project 21021 - Eliot MLK

Life Safety Checksheet Response

Permit #: 12-132453-000-00-CO

5 STORY MULTIFAMILY 50 UNIT APARTMENTS FOR LIMITED INCOME TENANTS. INCLUDES GROUND FLOOR RETAIL + SITE IMPROVEMENTS

CUSTOMER: **RAM FORCE COMPACTION**
DWG. SCALE **NTS** SHEET **1 OF 4**

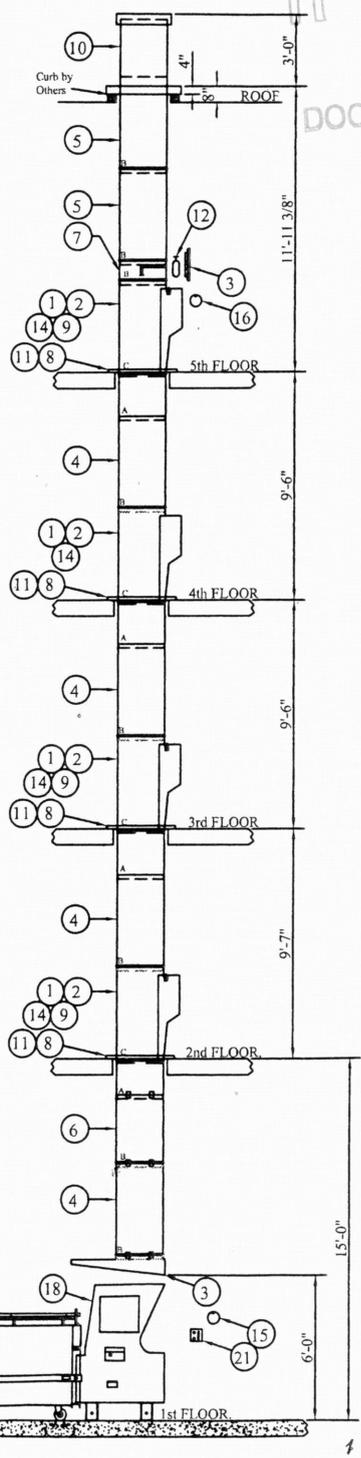
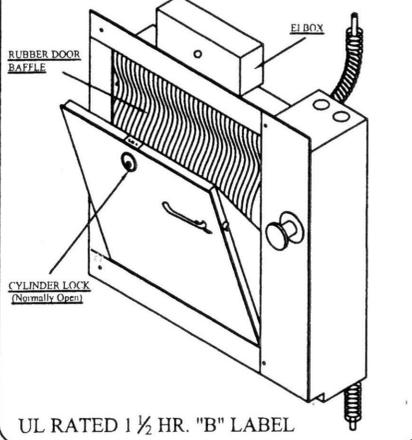
1ST TRANSMITTAL REVISE & RESUBMIT WARRANTY SHOP FABRICATION
